From: Coleman, Heather <HColeman@sanleandro.org>
Sent: Wednesday, November 28, 2018 12:30 PM
To: Mogensen, Andrew; Stella, Michael; Chen, Reh-Lin; Richardson, Tonya; Barros, Sally; Benabou, Isaac; Braun, Melanie; Miraftab, Matin; Jenson, Justin; Fluehr, Yvonne
Cc: Detterman, Mark, Env. Health; Khatri, Paresh, Env. Health
Subject: RE: PLN18-0080 AR Cozy Nest Adult Day Care Transmittal - 2125 Williams St
Attachments: PLN18-0080 Submittal 2 Internal Dist Pkg 11.28.18.pdf

Subject: PLN18-0080 AR Cozy Nest Adult Day Care Transmittal - 2125 Williams St

Submittal #2
2125 Williams St. | Cozy Nest Adult Day Care
COMMENTS DUE Wednesday, December 12, 2018
DISTRIBUTION SHEET INTERDEPARTMENTAL DEVELOPMENT REVIEW

PROJECT **PLN18-0080**

EXISTING SITE PLAN / PARCEL PLAN

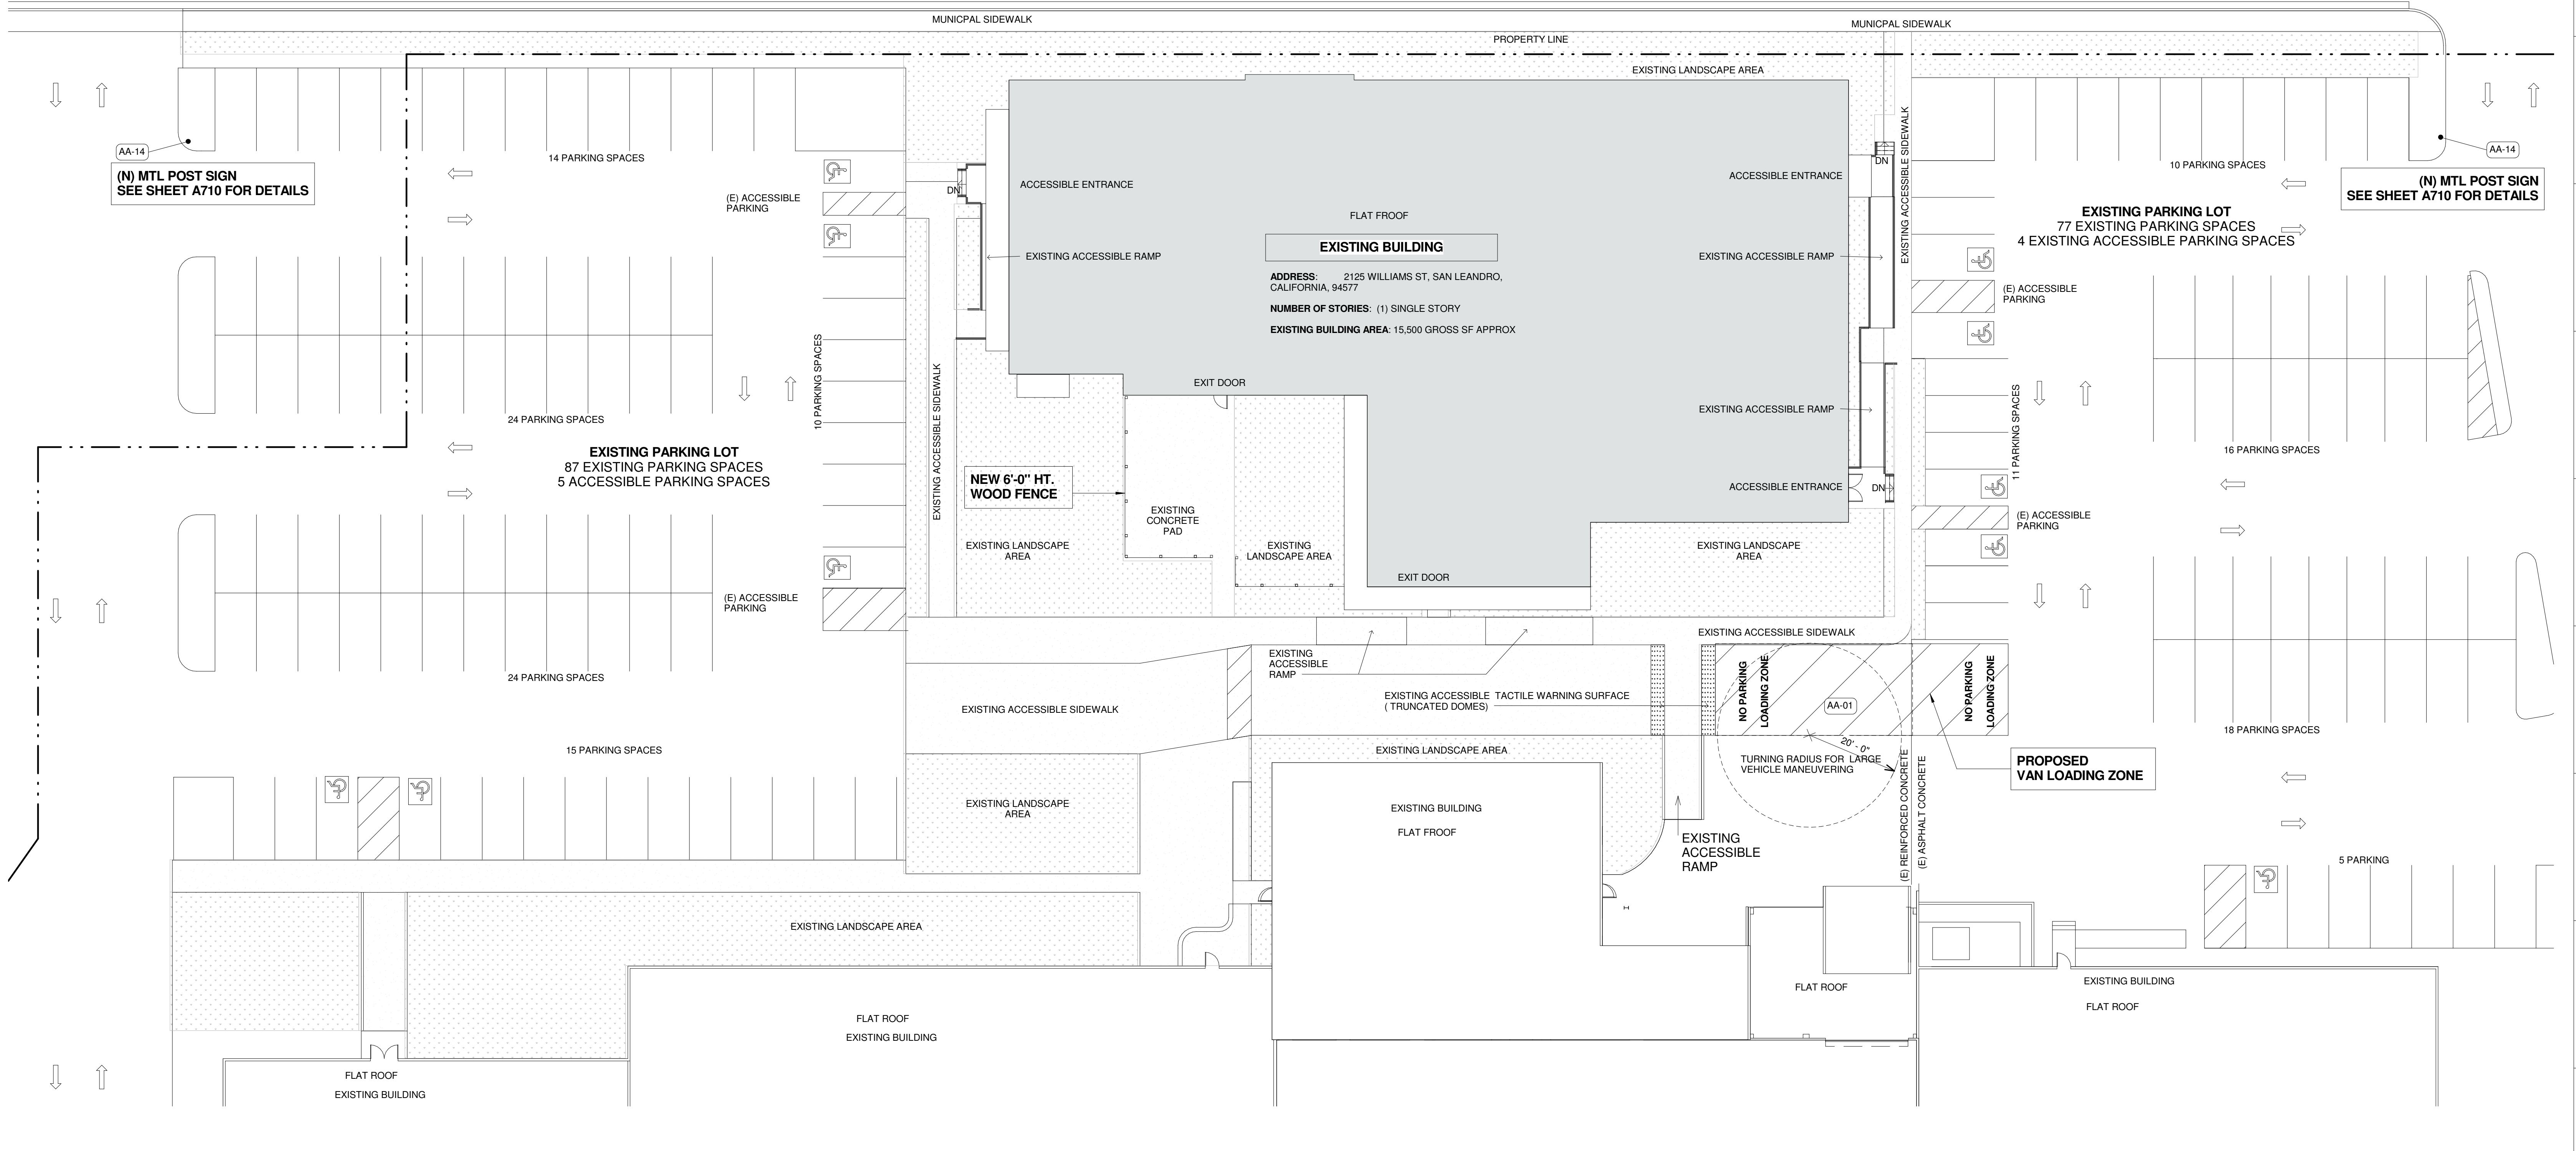
3. **Parking Requirements and Parking Demand.** The table on Sheet A090 (“Existing Site Plan/Parcel Plan”) has a calculation of parking required by the San Leandro Zoning Code. Thank you for providing this break-down of required parking by land use category. Please clarify the following items:

- a. Rectify the number of parking spaces required for existing tenants between Sheet A090 and the letter submitted by Jones Development Company.
 - b. You have calculated required parking for the building at 2101 Williams St. based on the land use classification “Offices, Business and Professional.” However, the correct land use classification for the adult day care facility you are proposing is “Day Care, General,” for which the parking requirement is one parking space per six children. Although the requirement is stated in terms of “children,” and the facility is proposed to serve adults, the parking ratio is intended to be applied in terms of clients. Please include a calculation of the required parking based on the number of clients.

- a. Calculation on A090 has been updated to reflect the information provided by the Property owner.
 - b. Calculation has been updated to reflect 1 space / 6 occupants, with 545 occupants we are required to provide 91 parking spaces.

A300
 PROPOSED PLAN

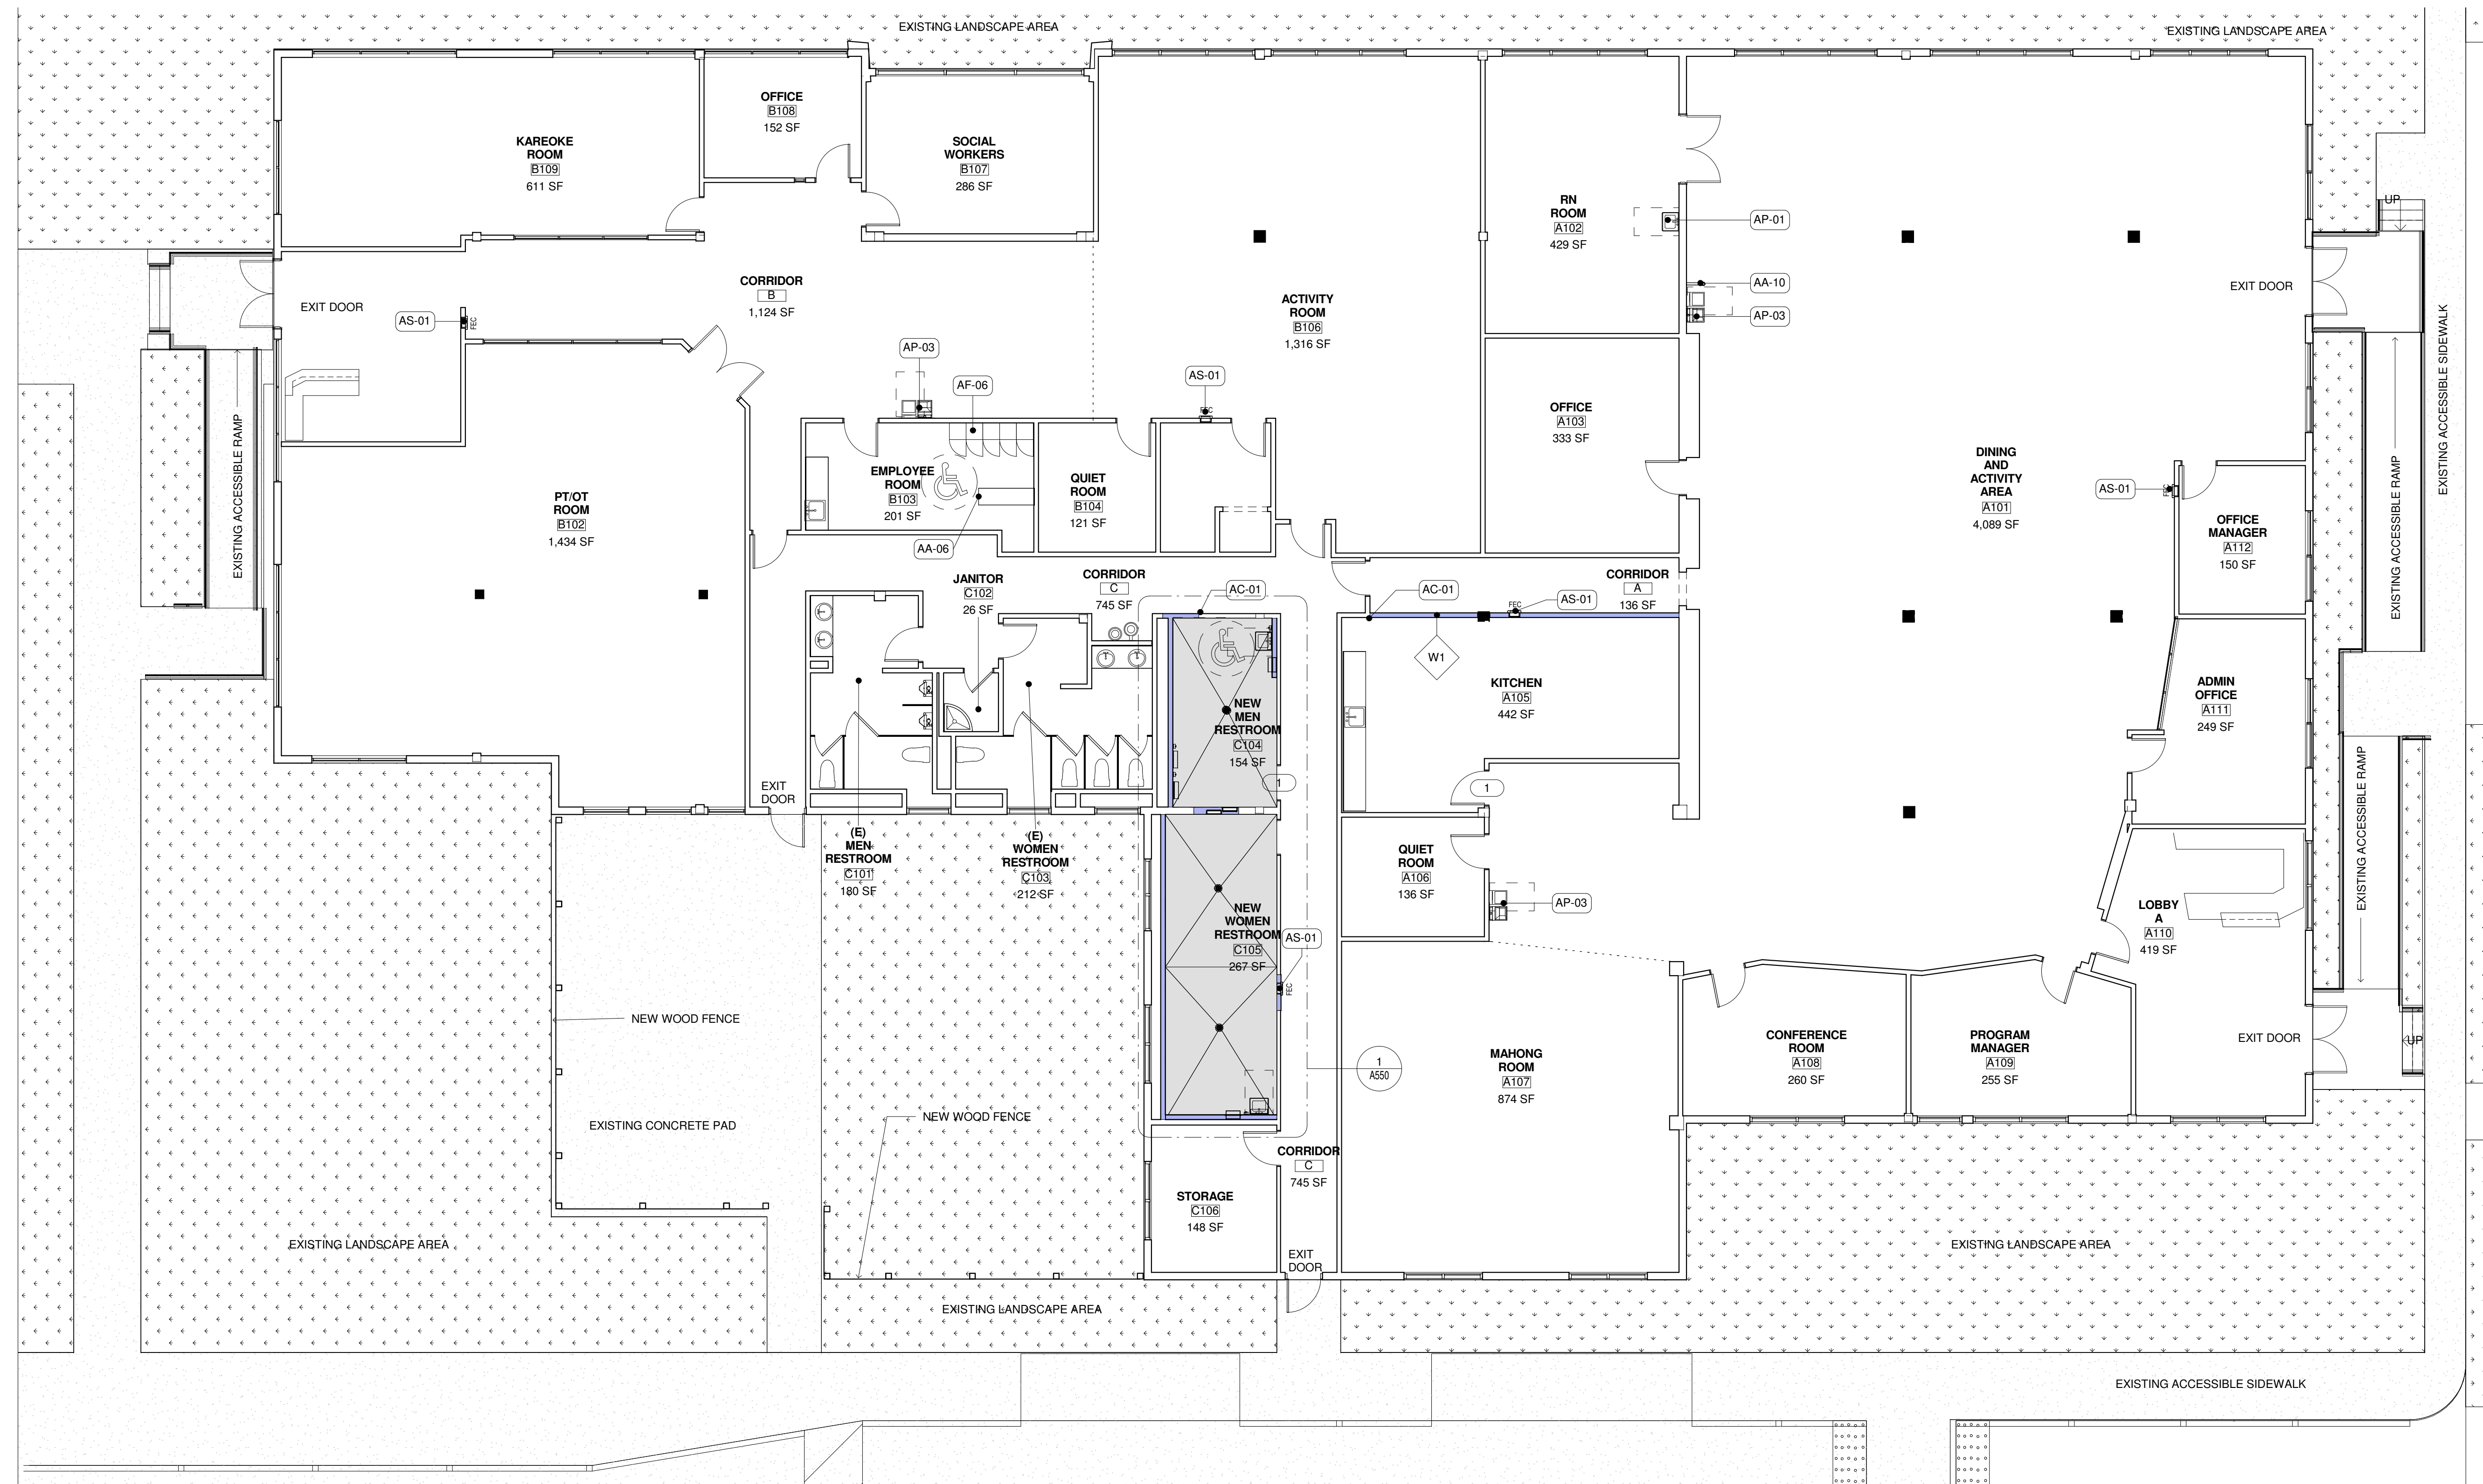
18. On sheet A300 there is a note stating: Smoke Detector- all rooms to be provided with smoke detectors UL Listed. Provide the code section requiring the smoke detectors.

14. Correct address is 2125 William Street, as noted on the Cover Sheet.
15. The Building is fully Sprinklered, note has been revised on the Cover Sheet.
16. The building has Fire alarm system.
17. Note has been revised on the Cover Sheet, the building is fully sprinklered and has fully functioning Fire alarm system.
18. Floor Plans have been updated.
19. Exit analysis has been clearly shown on Sheet A310.

A310
SAFETY AND ACCESSIBILITY PLAN

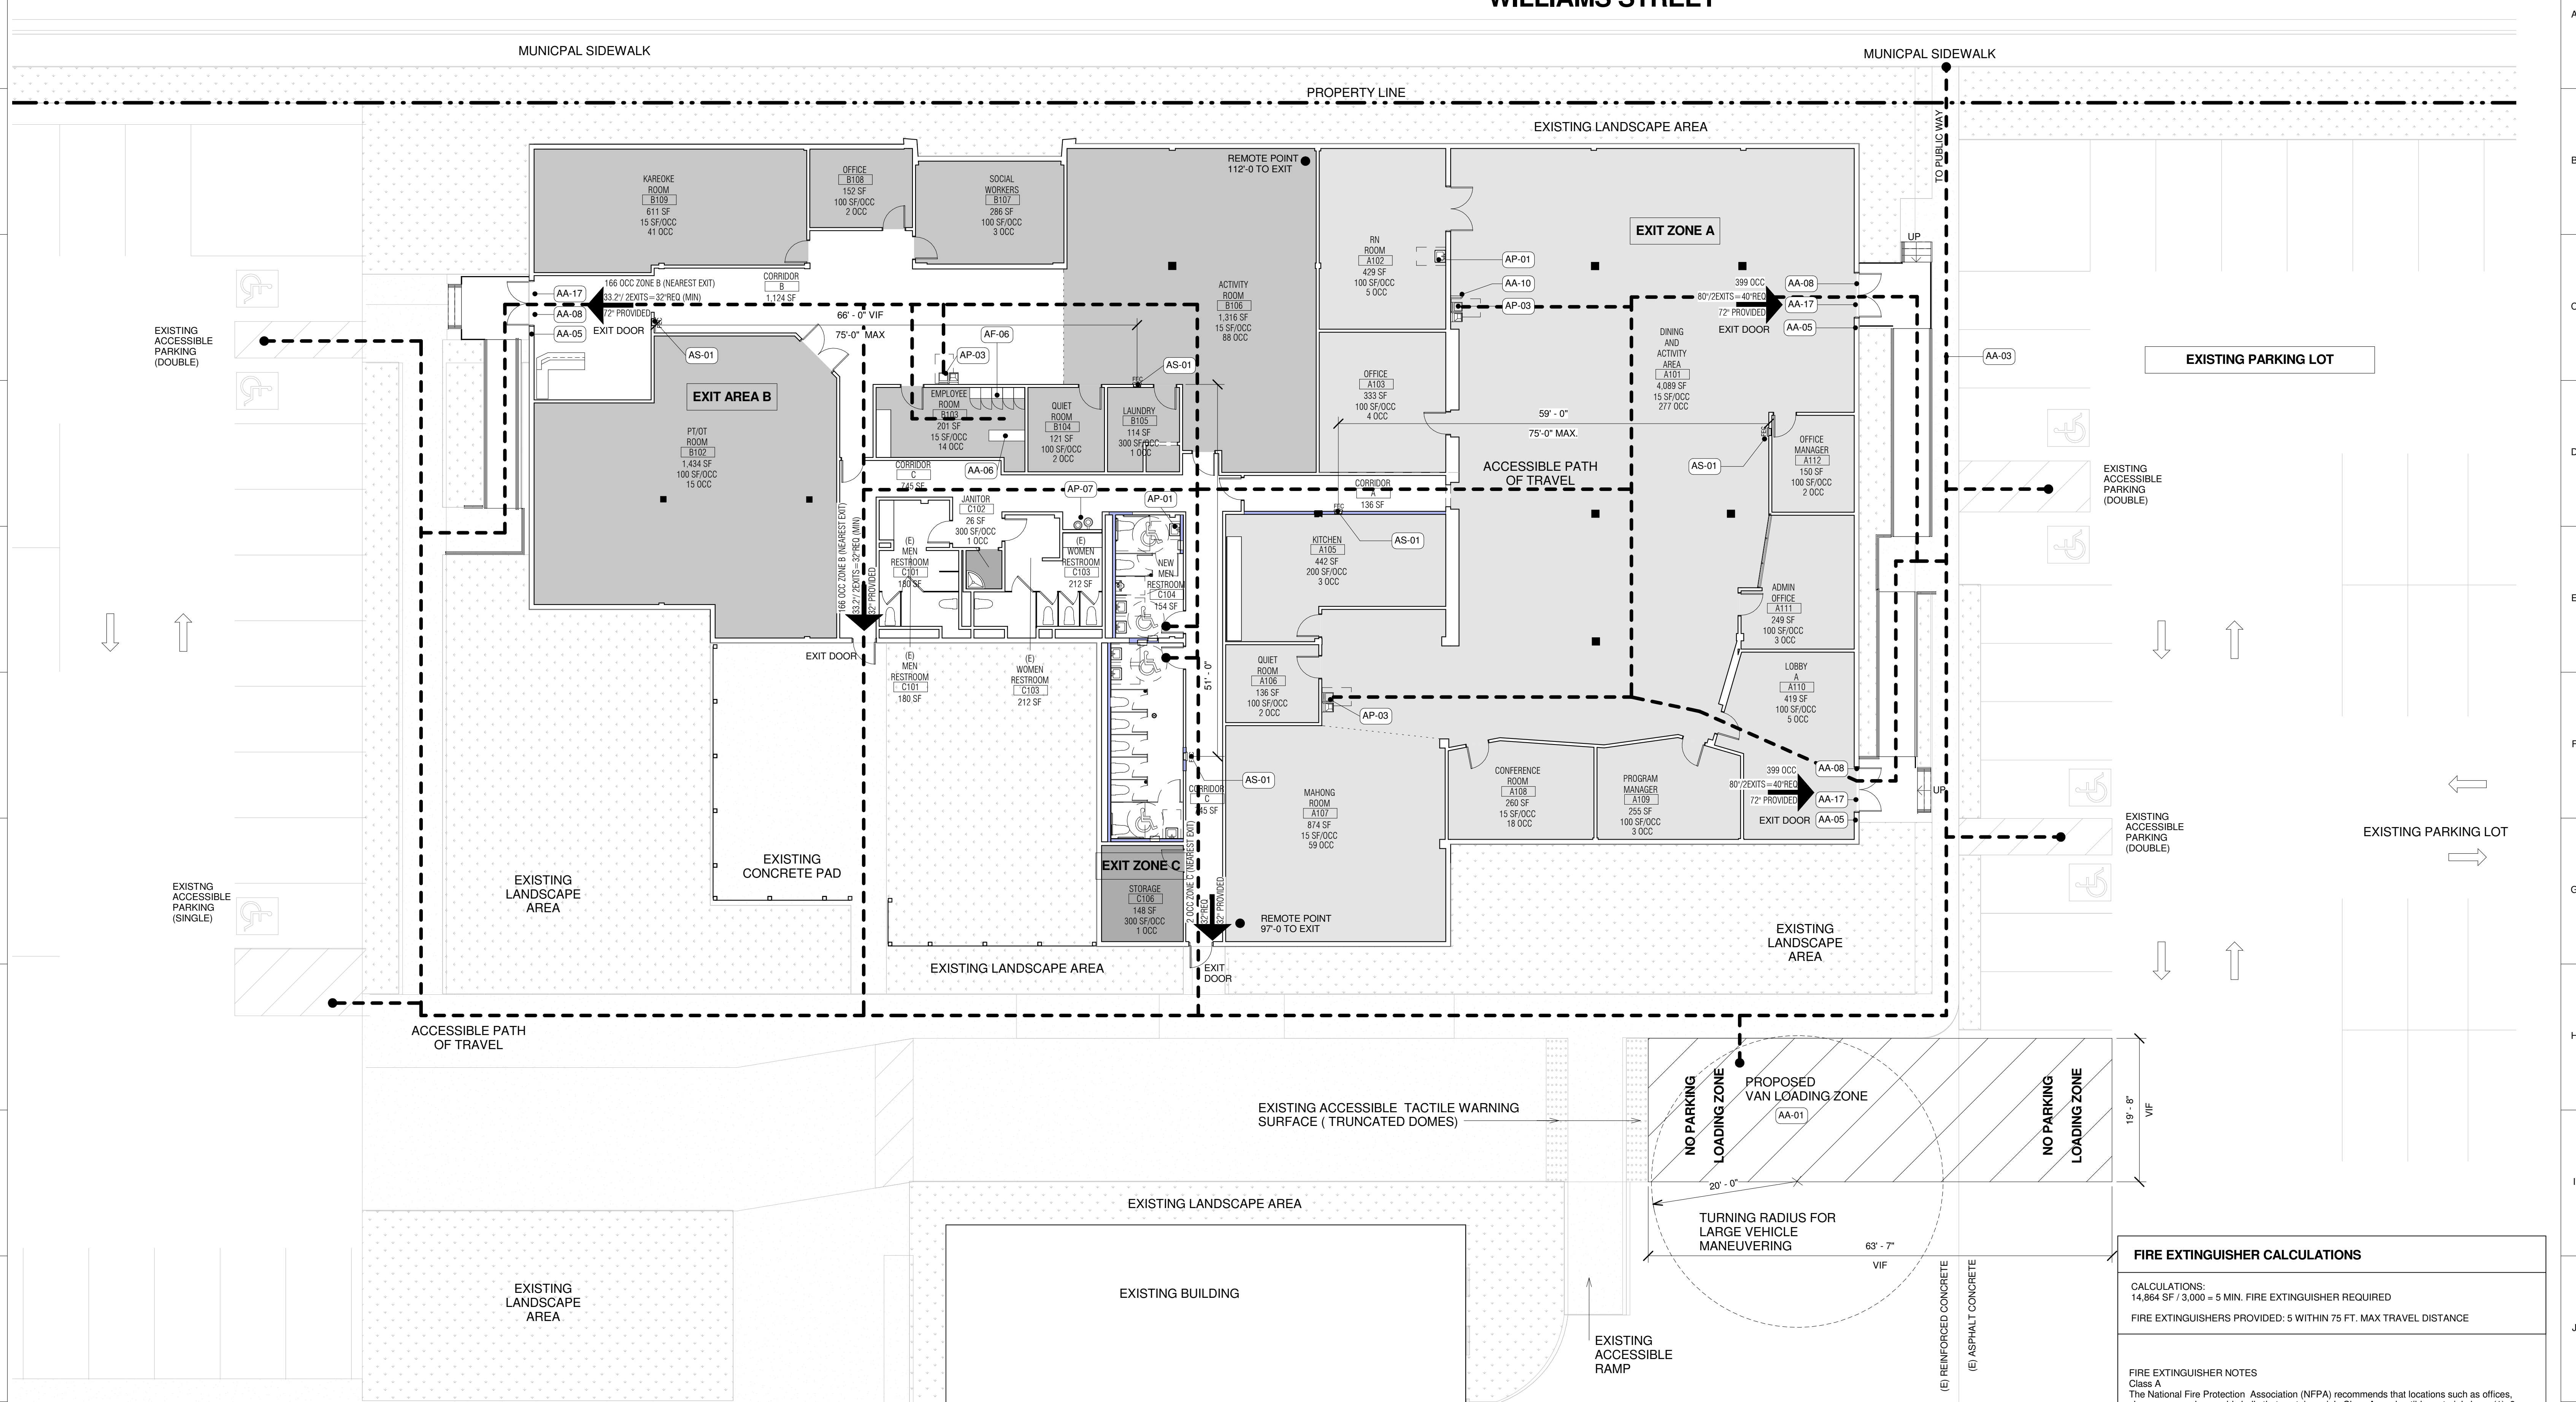
19. On sheet A310 provide an exit analysis clearly showing how egress is achieved for all occupants. Show the number of occupants for each exit. Clearly show how the assembly exiting meets the requirements of Section 1029.2 of the 2016 California Building Code.
